# MIAMI BEACH

### Staff Report & Recommendation

### Design Review Board

SUBJECT: DRB06-0102  
**5712 North Bay Road – Single Family Home**

Portion of the 1925 Amended Plat of La Gorce Golf Subdivision (subject property Lot 42)

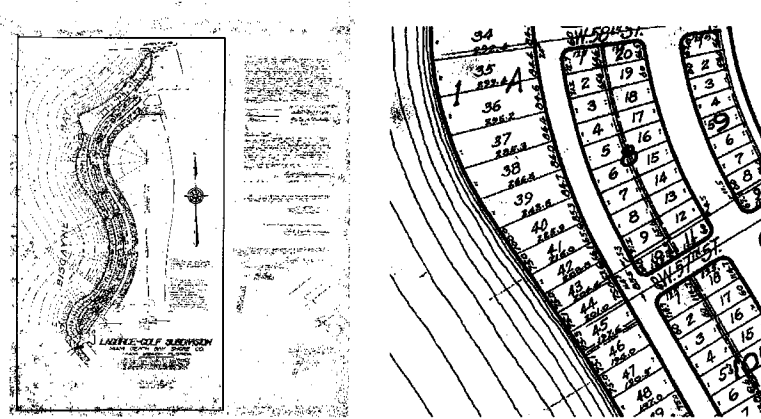
These two (2) variances are related to the same zoning regulation. The subject property is an interior lot on a block within the Amended Plat of Sunset Lake Subdivision, which was historically platted on April 08, 1925 as a series of two and half blocks west of the La Gorce Golf Course and ending at Biscayne Bay, of which the subject property is part and parcel of. Lot 42, the subject property, was platted with a frontage of 66.1'-0" and a water frontage of 75'-0". The recent changes to Section 142-106 pertaining to side setback requirements require that lots with over 60'-0" in width have an increased setback of a minimum of 10'-0" along both side yards. Lots with 60'-0" or less of frontage have a minimum of 7'-6" required side setback.

This would require the subject property, with 6.1' (or 73") of additional frontage, to offset the building envelope an additional 5'-0" (2'-6" for each side). Since this is new construction, and no hardship can be identified, staff is not supportive of the variance request. Should the Board find that the request is 'de minimus' and that without the granting of this variance, the construction of the building on the lot would be more restrictive than its immediate neighbors and the site could not be developed as other lots in the same district and same platted subdivision the variance could be granted. The proposed setback of 7'-6" on one side is consistent with the existing setback conditions for the other surrounding properties. Therefore, the applicant's request would not create a negative impact upon the neighboring properties. The size of the property and its current parallelogram shape are the same original parcel geometric configuration.
